MEMORANDUM

Subject: Addendum to MovingAhead Alternatives Analysis Technical Reports

This document is an addendum to the MovingAhead Project's Alternatives Analysis (AA) Draft Final Technical Reports, dated May 2017. This addendum serves to provide new options for mitigating potential adverse effects as related to the information gathered by the AA Technical Reports.

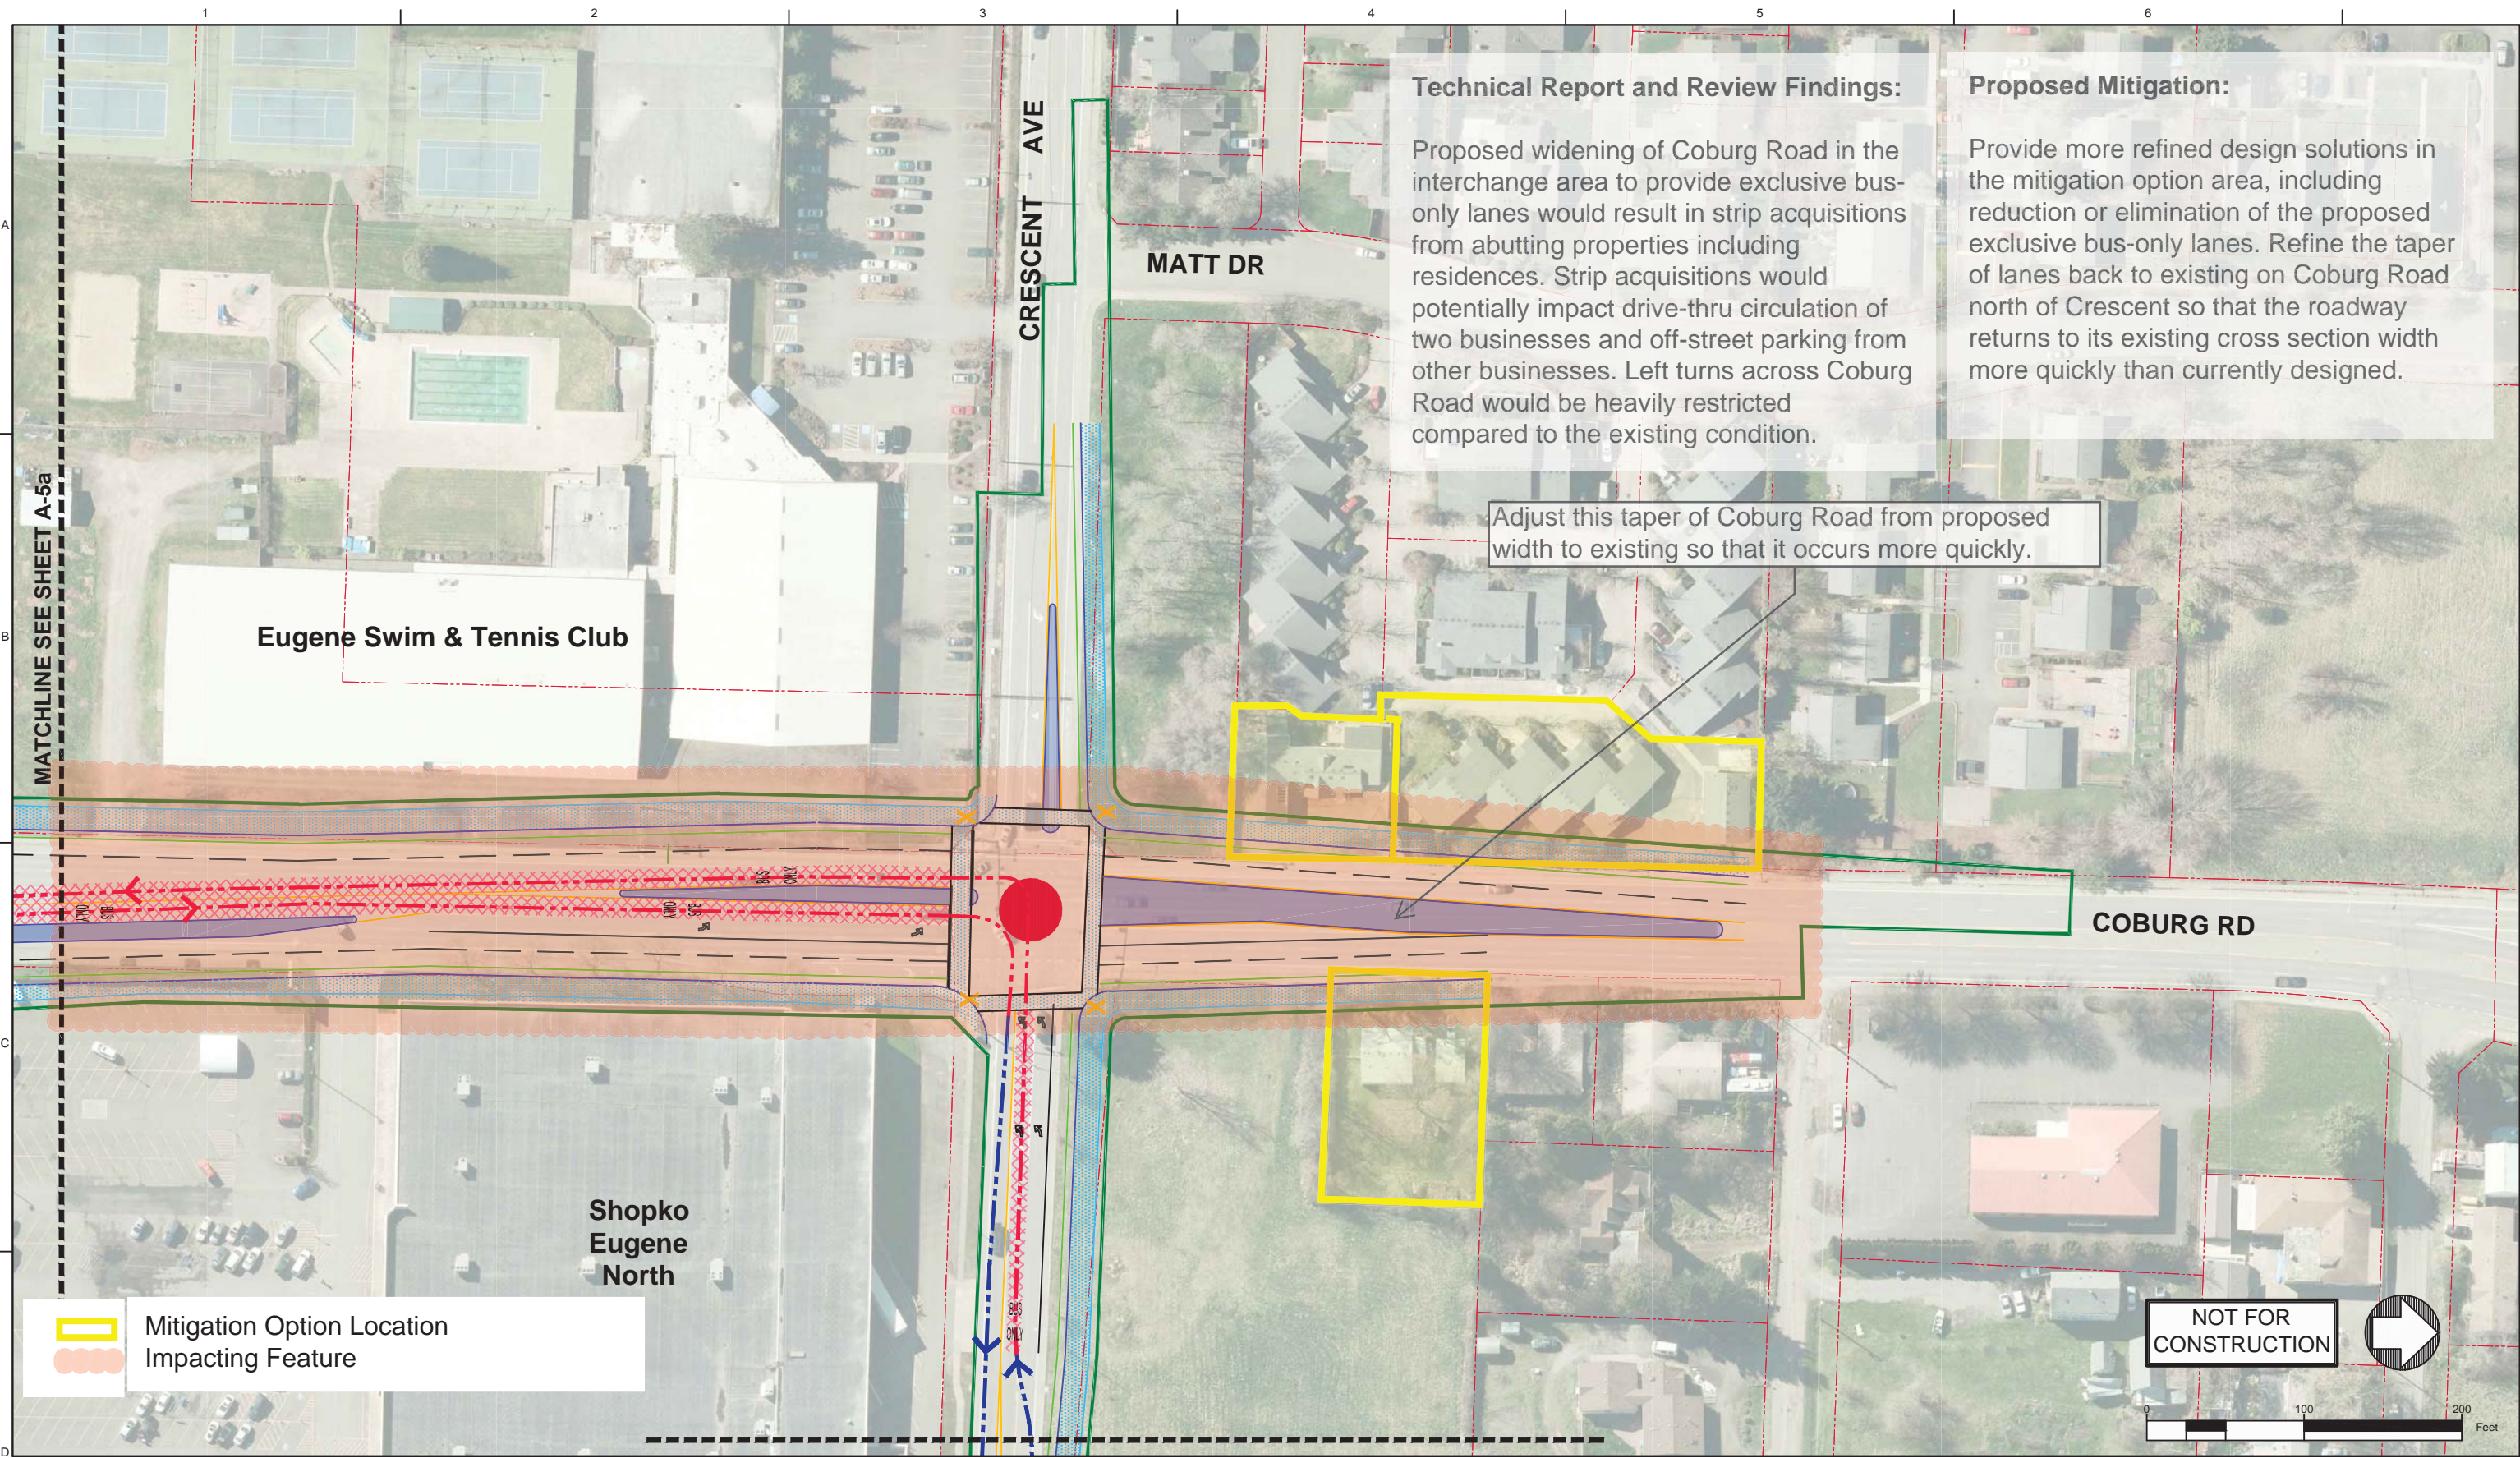
Proposed widening of Coburg Road in the interchange area to provide exclusive bus-only lanes would result in strip acquisitions from abutting properties including residences. Strip acquisitions would potentially impact drive-thru circulation of two businesses and off-street parking from other businesses. Left turns across Coburg Road would be heavily restricted compared to the existing condition.

Provide more refined design solutions in the mitigation option area, including reduction or elimination of the proposed exclusive bus-only lanes. Refine the taper of lanes back to existing on Coburg Road north of Crescent so that the roadway returns to its existing cross section width more quickly than currently designed.

COBURG ROAD CORRIDOR
EmX ALTERNATIVE
Corridor-Based Mitigation

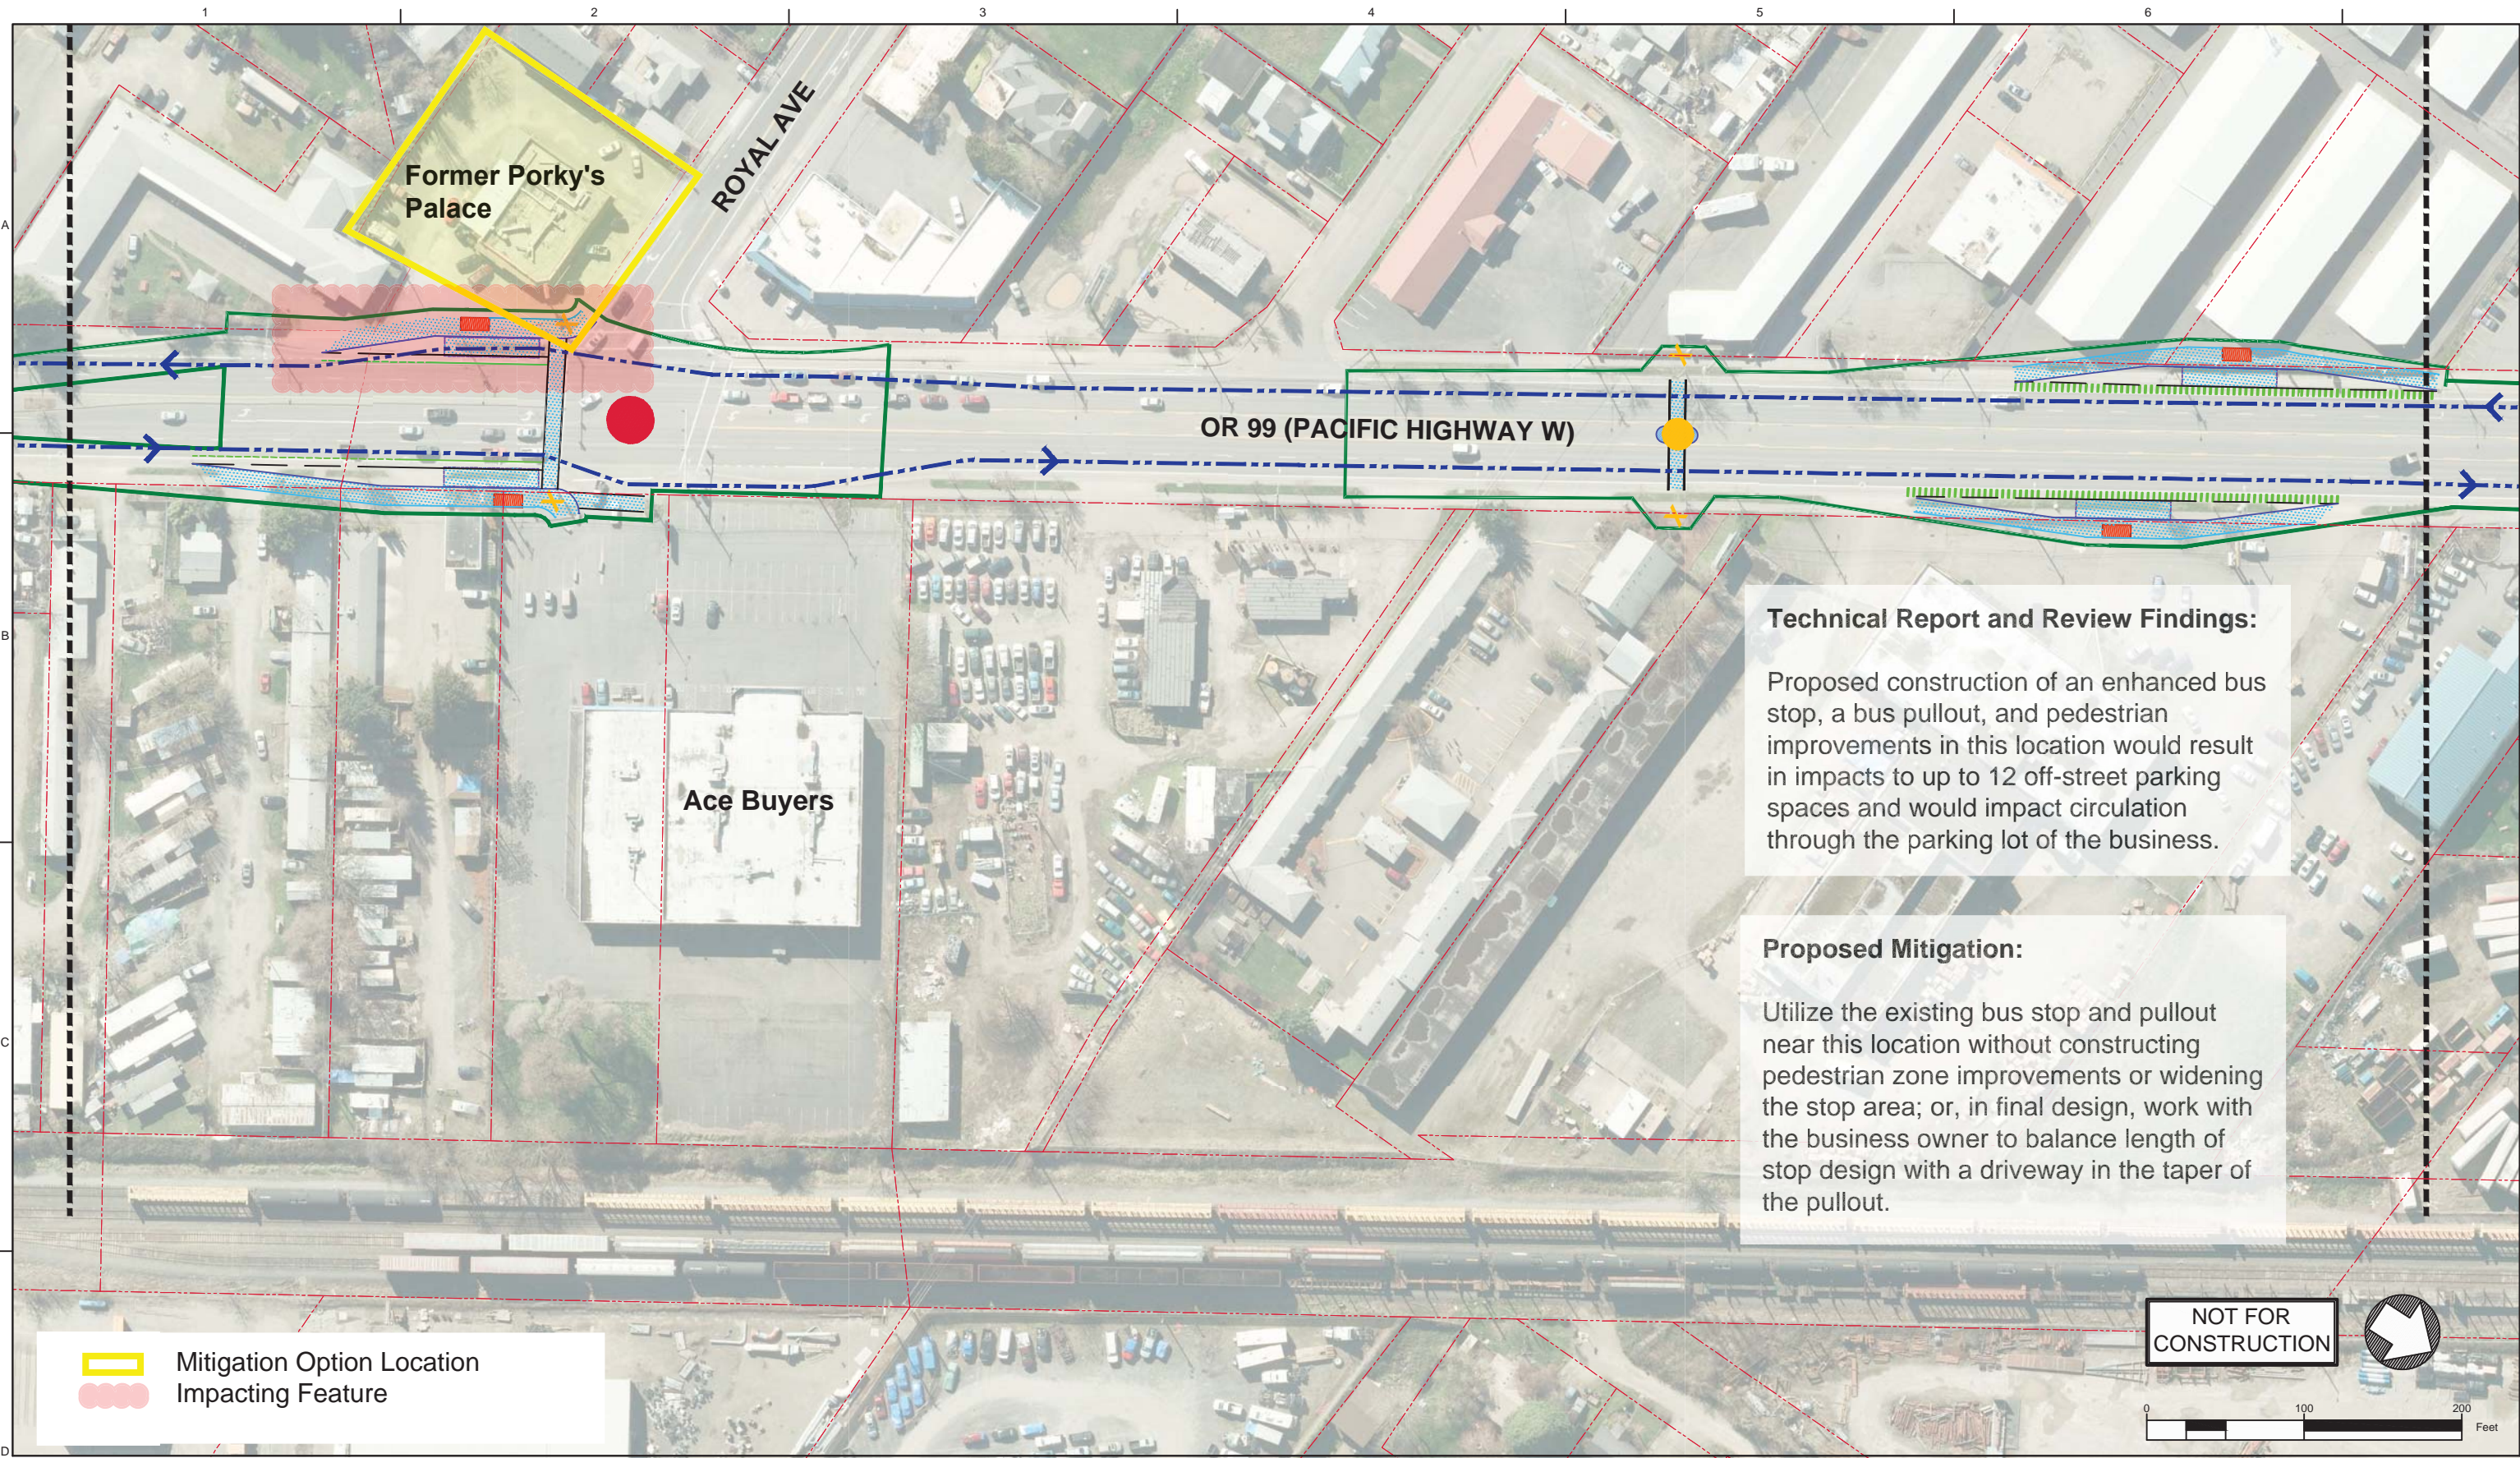
Proposed widening of Coburg Road in the interchange area to provide exclusive bus-only lanes would result in strip acquisitions from abutting properties including residences. Strip acquisitions would potentially impact drive-thru circulation of two businesses and off-street parking from other businesses. Left turns across Coburg Road would be heavily restricted compared to the existing condition.

Provide more refined design solutions in the mitigation option area, including reduction or elimination of the proposed exclusive bus-only lanes. Refine the taper of lanes back to existing on Coburg Road north of Crescent so that the roadway returns to its existing cross section width more quickly than currently designed.
